Strategic Housing Development at  
North Wall Quay, Co. Dublin

Quality Audit

**Document Ref:** P20-096-UQA-GEN-RP-001

#### 3.3.1 Problem

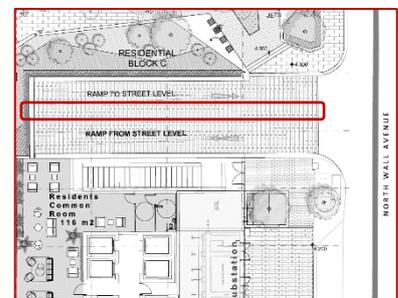
Summary: *Insufficient inter-visibility between drivers exiting the basement access ramp and pedestrians/drivers on North Wall Avenue may lead to side-on and vehicle/pedestrian collisions.*

A tree is indicated to the south of the basement carpark access ramp and may reduce inter-visibility between drivers exiting the basement carpark and pedestrians/drivers on North Wall Avenue. Insufficient inter-visibility at the basement carpark access may lead to drivers entering North Wall Avenue, or crossing the footway, when it is unsafe to do so, leading to side-on or vehicle/pedestrian collisions.

Additionally, inset parallel parking bays on North Wall Avenue may further reduce a driver’s visibility when exiting the basement carpark, leading to side-on collisions.

Remove/relocate the tree indicated to the south of the basement carpark access ramp and ensure visibility splays are not obstructed by vehicles parking within the inset parking bays.

#### 3.3.2 Problem

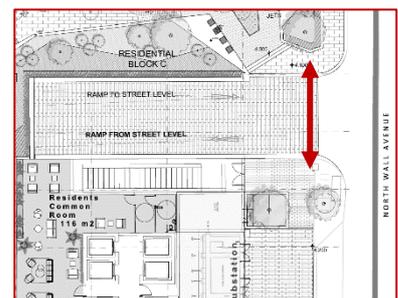
Summary: *The absence of lane separation on the basement carpark access ramp may result in low speed head-on collisions.*

The basement carpark access ramp does not include lane separation, such as road markings or physical measures. The absence of lane separation measures to clearly advise drivers of the entry and exit lanes may lead to drivers adopting a central position on the ramp, which may increase the risk of low speed head-on collisions with opposing vehicles.

Provide lane separation measures on all vehicle access ramps within the development.

#### 3.3.3 Problem

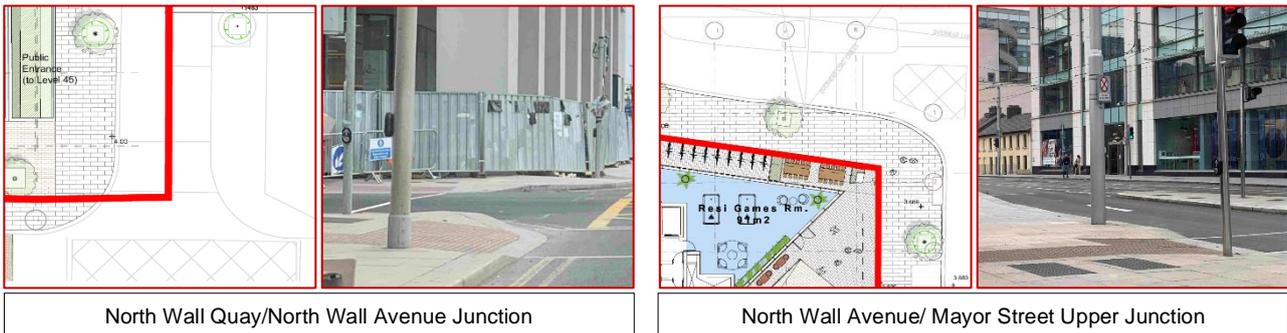
Summary: *No formal pedestrian crossing has been indicated at the development’s basement carpark access ramp, which could lead to slips, trips, and falls.*

A failure to provide dropped kerbs and tactile paving, or a continuous footway across the basement carpark access ramp, could result in mobility and visually impaired pedestrians on North Wall Avenue being unable to cross the access ramp safely and independently. This could result in slips, trips, or falls as these pedestrians attempt to descend the kerb.

Prioritise pedestrian movements across the development's access by providing a continuous footpath.

Alternatively, a formal uncontrolled pedestrian crossing, including dropped kerbs and tactile paving, should be provided at the development's basement carpark access.

### 3.3.4 Problem

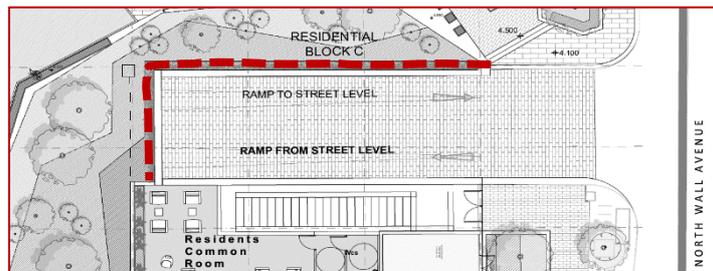
*Summary:* Removal of existing tactile paving may lead to visually impaired pedestrians being unable to locate the existing controlled pedestrian crossings or stepping into the carriageway without due care and attention, leading to vehicle/pedestrian collisions.

Existing tactile paving at the junction of North Wall Quay/North Wall Avenue and North Wall Avenue/ Mayor Street Upper is not indicated on the design drawings issued for Audit. Should the existing tactile paving be removed as part of the development, or fail to be modified to accommodate the development's footprint, there is a risk that visually impaired pedestrians may find it difficult to locate and correctly use the signalised pedestrian crossings, and enter the carriageway when it is unsafe to do so, leading to vehicle/pedestrian collisions.

The existing tactile paving should be incorporated within the development's design and be modified to seamlessly tie-in with the development's footprint (e.g. tactile stem extended to the new back of footway).

**3.3.6 Problem**

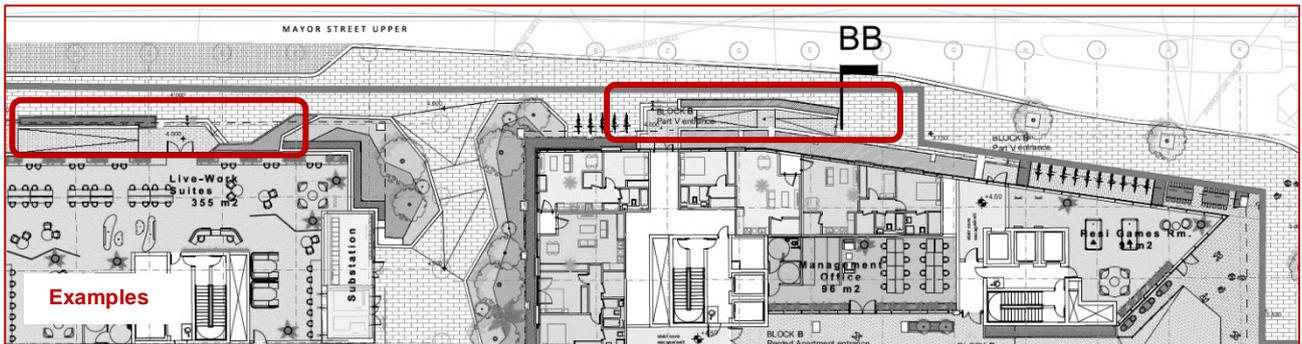
Summary: *Unprotected water feature could lead to serious personal injury, or drowning.*

It is unclear if any edge protection is proposed at the water feature near Apartment Block A. The absence of edge protection at the water feature may increase the risk of pedestrians, particularly small children, falling into the water feature and suffering serious injury, or drowning.

Suitable edge protection measures should be provided at the water feature.

### 3.3.8 Problem

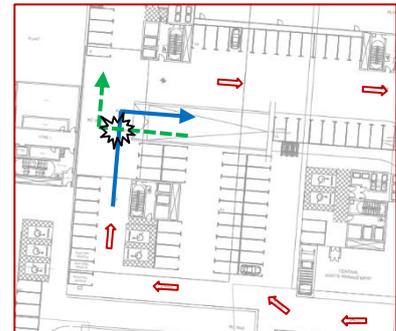
*Summary: Direction of one-way system on Basement Level -3 may increase risk of conflicts at ramp access, leading to side-on and material damage collisions.*

The clockwise direction of the one-way system indicated on Basement Level -3 will require vehicles entering/exiting the ramp to cross at the ramp access. This crossing manoeuvre may increase the risk of side-on and material damage collisions.

The direction of the one-way system should be reversed, such that traffic travels in an anti-clockwise direction, thus negating the need for vehicles to cross at the ramp access.

### 3.3.9 Problem

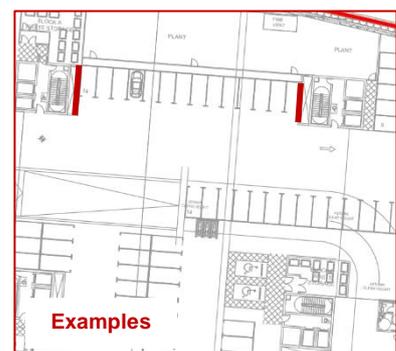
*Summary: Basement carpark do not include clearly designated pedestrian routes, which may increase the risk of vehicle/pedestrian collisions.*

Basement carpark layouts do not indicate pedestrian walkways or designated pedestrian routes. As a result, pedestrians may unintentionally choose routes that bring them into direct conflict with vehicles, particularly in locations where inter-visibility is reduced by structural columns and walls.

Similarly, the basement carpark layouts indicate that pedestrians travelling from the stairwell/elevator will need to pass between narrow gaps in the parking arrangement, where inter-visibility between drivers and pedestrians will be significantly reduced.

Insufficient inter-visibility between drivers and pedestrians may increase the risk of vehicle/pedestrian collisions.

Provide clear pedestrian routes within the basement carpark and ensure adequate inter-visibility between drivers and pedestrians on key pedestrian desire lines.

### 3.3.10 Problem

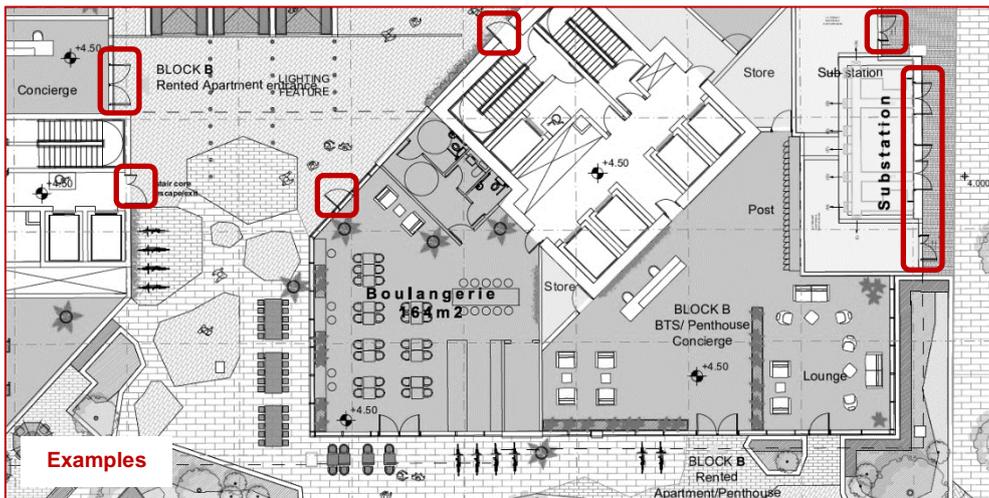
*Summary: Drivers exiting parking spaces adjacent to the basement walls will have restricted visibility, which may lead to side-on or vehicle/pedestrian collisions.*

Vehicles exiting from parking spaces immediately adjacent to the elevator/stairwell blocks will have restricted visibility towards approaching vehicles/pedestrians on the internal circulating lanes. This could result in low-speed side-on or vehicle/pedestrian collisions.

Remove parking spaces that are directly adjacent to the elevator/stairwell blocks.

Alternatively, use road markings to create a buffer zone that positions vehicles/pedestrians away from the elevator/stairwell block when travelling within the carpark.

#### 3.3.11 Problem

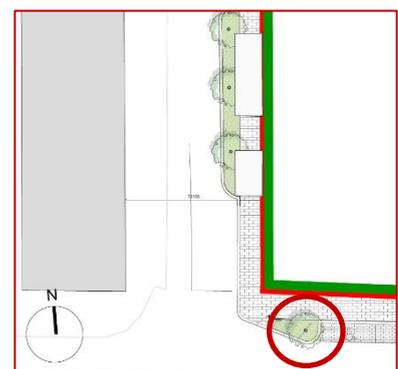
Summary: Doors opening into the footway may conflict with pedestrians and cyclists, leading to personal injury collisions.

A number of external doors associated with the development (e.g. substation onto the concourse near the northern extent of the development) are indicated as opening outwards. This arrangement can present a hazard to pedestrians/cyclists who may not anticipate a door opening into their path, leading to personal injury collisions, whilst also presenting difficulties for mobility-impaired road users.

Doors should open into the building so as not to obstruct or conflict with pedestrians and cyclists on the footway.

However, this recommendation should not be adopted should it directly contradict building and fire safety regulations. Should building and fire regulations require the doors to open into the footway (i.e. open outwards), measures should be provided to alert pedestrians and cyclists.

#### 4.2.2 Issue

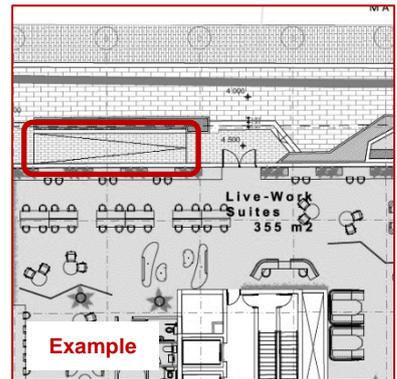
It is not clear from the design drawings if the public garden spaces is flush with the surrounding paved areas, or if a kerb upstand is provided around its perimeter.

Should the public garden spaces be provided on a raised level, without ramps or dropped kerbs for access, mobility impaired users may be unable to access, and be discouraged from using, the amenity.

Ensure mobility impaired users can safely access the public garden spaces.

#### 4.2.3 Issue

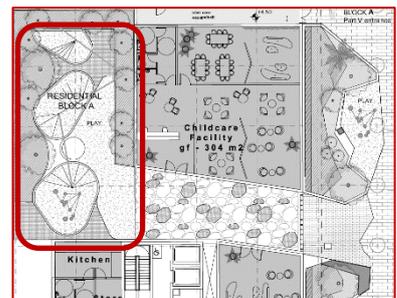
Footway gradients within the development are unclear and could lead to user discomfort if long ramps with gradients steeper than 1:20 are provided.

Ensure ramps are constructed in accordance with the National Disability Authority's guidance publication "Building for Everyone (External Environment and Approach)".

#### 4.3.2 Issue

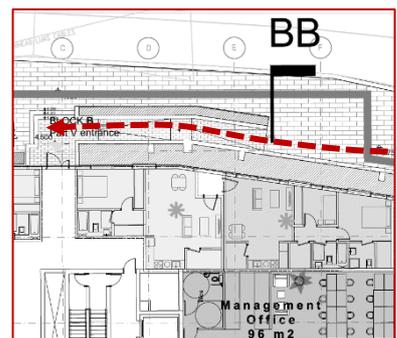
Visually impaired pedestrians walking in a westbound direction on Mayor Street Upper may unintentionally continue onto the pedestrian basement access ramp, which has no through route, and become disoriented and confused.

Provide corduroy tactile paving at the start of the pedestrian basement access ramp, and colour contrast, to better advise and direct visually impaired pedestrians using Mayor Street Upper.
